**AMENDMENT NO. 1 JANUARY 1996
TO
IS 13828 : 1993 IMPROVING EARTHQUAKE
RESISTANCE OF LOW STRENGTH MASONRY
BUILDINGS — GUIDELINES**

FIG. 5 STRENGTHENING MASONRY AROUND OPENING

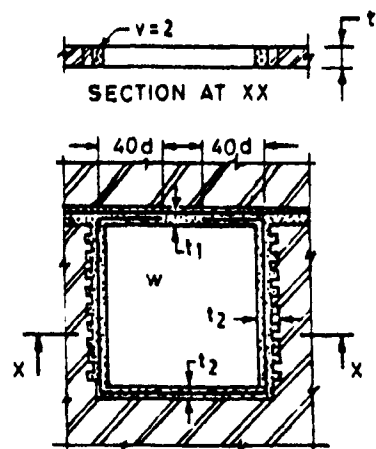
(Page 6, Figure 5) — Substitute the following for the existing figure:

W = Window t₂ = Thickness of concrete in jamb
t = Wall thickness v = Vertical bar
t₁ = Lintel thickness d = Diameter of reinforcing bars
